8.5 Secured by Design

Richmond Design Review Panel

8.6 Planning objection comments

Massing improvements – Gould Road & Crane Road (pre-application 2 comment)

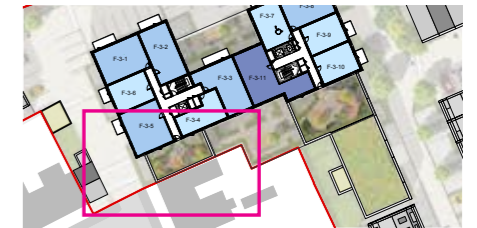
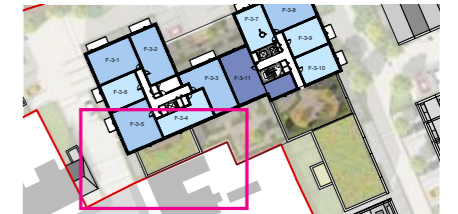
- Concerns over the massing at the junction of Gould Road and Crane Road in relation to existing terraces and overlooking from the roof gardens in Building F;
- Review the lantern roof and look at the option of a flat roof instead; not convinced of the darker tone.

- The roof of Building F appears over-heavy and appears to emphasise the upper-storey finish.

We have tested a variety of approaches in response to these comments. The flat roof option was tested but this gave a very blocky form that is largely alien to the area and did not compliment the existing roofscape. The following design amendments were subsequently made:

- Reduced parapet and roof terrace extent at junction of Gould Road and Crane Road, improving the relationship with the existing terrace of houses and reducing potential overlooking from the roof terrace;
- Amended treatment of fourth floor and roof profile to reduce visual impact from the street;
- Different material to reduce 'heavy' appearance;
- Retained lantern profile and roof pitch within a gable to best respond to existing buildings on site and local character.

Section showing visibility splay from balconies

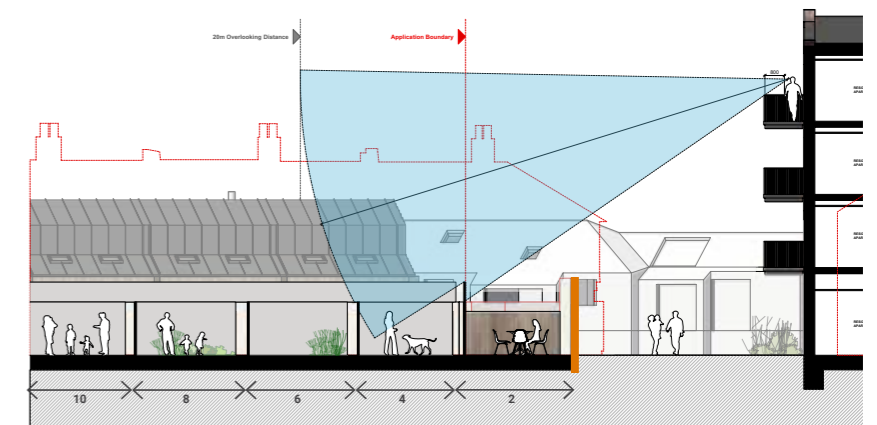
Fourth storey and balconies to the western end of Building F could have a negative impact and potential overlooking.

A full review of overlooking has been undertaken on these properties. The current proposal does not overlook existing windows, but does partially overlook the gardens of 4 Gould Road. Overlooking of gardens is a common condition within the area and within London and was considered acceptable by officers as part of the previous application. It is also important new apartments are provided with balconies where possible to meet London Plan.

However the design incorporates the following changes to reduce this perceived overlooking to benefit the existing owners of the gardens.

- Overlooking to neighbouring gardens minimised by garden of number 2 Gould Road and proposal to increase height of existing perimeter wall at site application boundary;
- Balcony railings amended to blades directing views towards the river providing residents with additional privacy and reducing overlooking from those sitting on the balcony or within the rooms.

Lux level analysis from lighting report

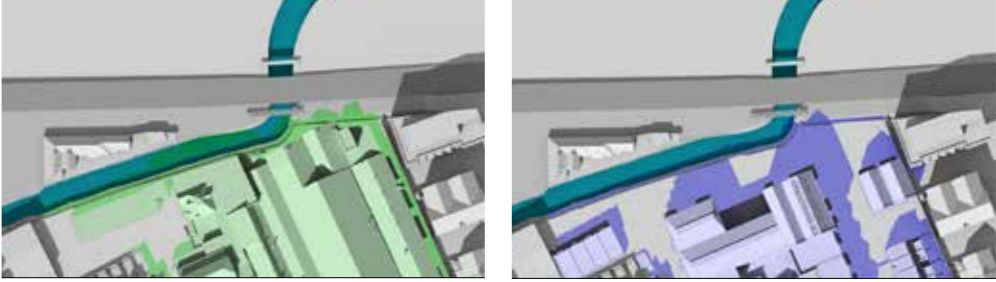
Lighting encroaching on the river corridor and channel (EA comment)
The scheme makes note of a sensitive lighting plan suitable for light sensitive species such as bats that are known in the area. We support the plan to use such lighting schemes however we feel the lighting is still encroaching on the river corridor and channel. Light-spill could be better prevented through the use of a natural corridor as a screen for the river.

Lighting encroaching on the river corridor and channel (FORCE comment)
We are concerned the proposed development – in particular the five-storey buildings facing the river – will increase light-spillage into the existing 'Dark Corridor' of the River Crane. Large accommodation buildings adjacent to the river will inevitably lead to extensive light pollution, having a detrimental impact on the environmental value of the river corridor.

Lighting encroaching on the river corridor and channel
An Exterior Lighting Assessment Supplementary Report has been prepared by Desco, in consultation with the Project Ecologists. This sets out that illuminance from the proposed development do not significantly impact the river 'Dark Corridor'. The proposals also represent an improvement upon the existing conditions, where factory windows are directly on the river edge and factory noise would also have been present.

The proposals have been further enhanced by the introduction of a low level wall, railings, tree planting and hedgerow to the river edge, which will further protect the river corridor from light encroachment.

Plan illustrating surrounding densities

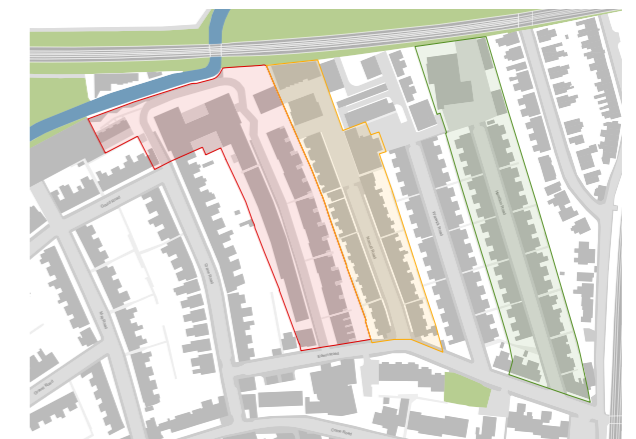
Some residents expressed concern that the scheme was too dense for the area and not in keeping with the urban grain of the surrounding streets.

We have undertaken the following analysis of our density compared with neighbouring streets in the surrounding area which indicates that the scheme is in line with the local context and achieves similar densities. Additionally the footprint of the proposals fits comfortably with the urban grain and pattern of the street scape.

Planning Submission Proposal Density Study: **362 hab. rooms / hectare, 103 units / hectare.**

Norcutt Road Density Study: **440 hab. rooms / hectare, 103 units / hectare, including approved student building.**

Hamilton Road Density Study: **396 hab. rooms / hectare, 99 units / hectare.**
